December 17, 2019

Re: **North Fork Water Main Bore Project (PR#186-2019)**
City of Nehalem (PWS ID#00554)
Conditional Approval

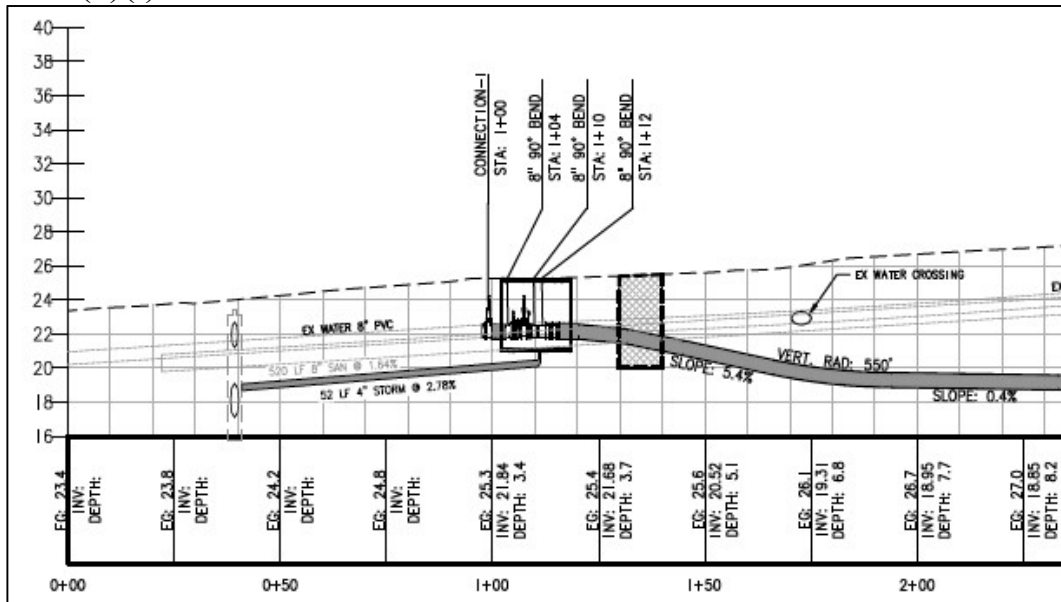
The project includes installation of roughly 1,840 LF of 8" DR-11, Class 200 fused HDPE waterline within Tillamook County public right-of-way for the North Fork Rd northeast of the City of Nehalem as shown below.

1. The Land Use Compatibility Statement (LUCS) was signed by the City of Nehalem Manager. It is unclear if this project extends beyond the City of Nehalem limits, therefore, a LUCS signed by Tillamook County may be needed. Please submit a LUCS signed by Tillamook Co. as applicable.
2. The design must allow for 20 psi to be maintained at the service meters.
3. Disinfection and testing of the waterline must be completed according to AWWA C651.
4. Air relief valves are placed at all high points in the waterline. Sta. 1+00 appears to be a high point and may need an air relief valve in accordance with OAR 333-061-0050(8)(i).

5. All items in contact with potable water must meet NSF Standard 61.
6. Parallel sewer/waterline separations must conform to OAR 333-061-0050(9). Note that any zone conflicts represented in Figure 1 in that rule other than zone 1 conflicts must be approved by OHA/DWS.
7. Any sewer and water line crossings must conform to OAR 333-061-0050(9)(c)(B). At all sewer crossings where the vertical separation between the waterline and the sewer

Figure 1: Water Line-Sewer Line Separation

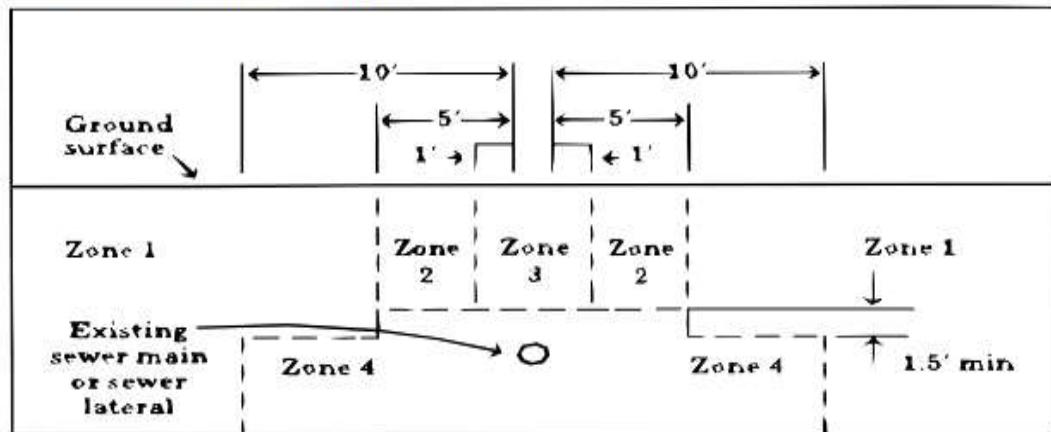
line is less than 1.5-ft, the sewer line should be inspected for leaks. If the sewer line is found to be in poor condition with evidence of leaks, the sewer line shall be replaced with a full length of pipe centered at the crossing point or the sewer shall be encased in a reinforced concrete jacket for a distance of 10-ft on both sides of the crossing. The plans indicate that until potholing is complete, separation of sewer and waterlines is uncertain. Note that any zone conflicts represented in Figure 1 other than in zone 1 must be approved by OHA/DWS.

Note: Refer to OAR 333-061-0050(9) and Figure 1 below. Please ensure record drawings indicate actual as-built sewer/water separations.
